ECE/TRANS/WP.29/GRRF/2010/5
23 November 2009

REGULATIONS Nos. 13 AND 13-H
(Braking)

Trailer braking

Proposal for amendments to Regulation No. 13

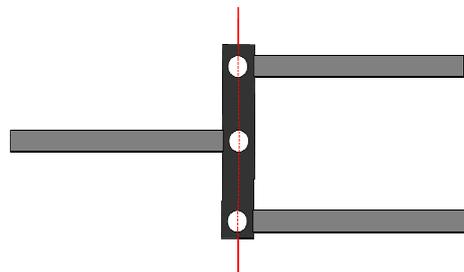
8.1.1. The pivot points in the compensator shall lie in a straight line with the park brake at the rest position.

All compensator pivots to be in-line

Alternative arrangements can be used, if they provide equal tension in both rear cables, even when there are differences in travel between the rear cables.

**"Figure 5A: MECHANICAL-TRANSMISSION BRAKING SYSTEM
(See paragraph 2.3. of this annex)**

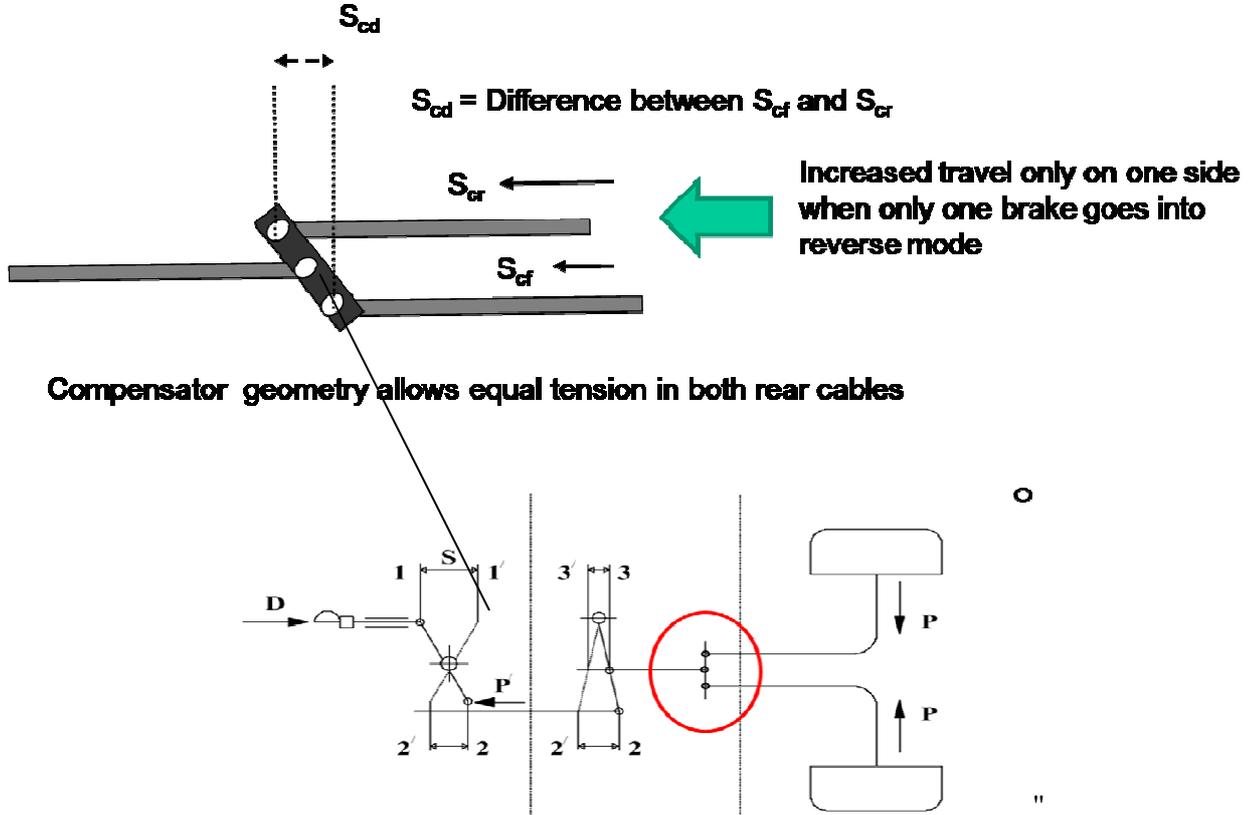
Appendix 1, insert a new figure 5A, to read:

Figure 2: Compensator operation

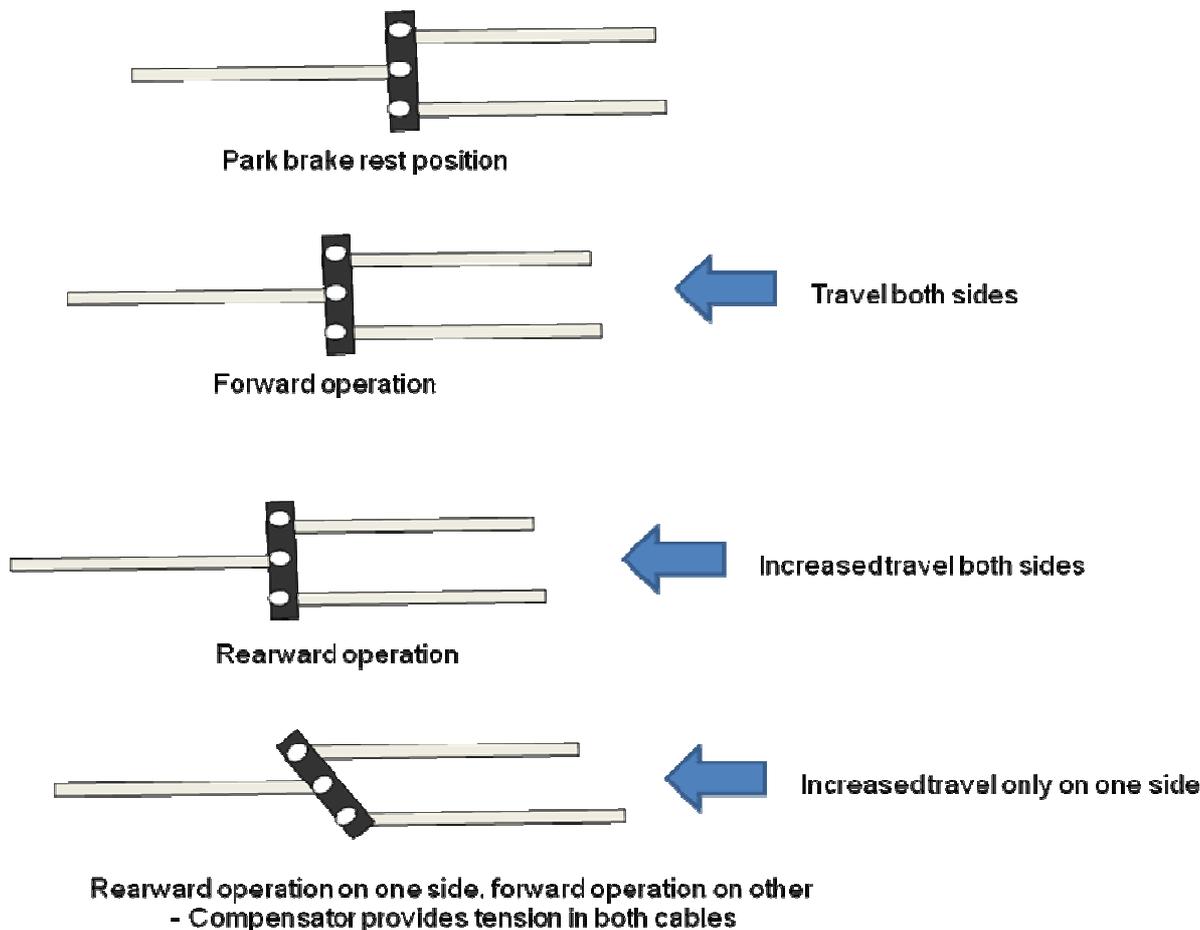
If the compensator design includes appropriate geometry, then both cables are subject to the same tension. Figure 2 shows the park brake operation of the compensator under various situations.

When the park brake is applied, the compensator applies tension to both rear cables. The compensator normally operates with either both brakes working in the forward or both in the reverse direction. However, if one wheel is stopped from moving by an external force (e.g. held against the kerb), then one brake can remain in the forward operating direction and the other will move into the reverse mode. This results in different travels in the left and right cables. The compensator must tilt to ensure that both cables are still held under the appropriate tension. This is shown in the last diagram in Figure 2.
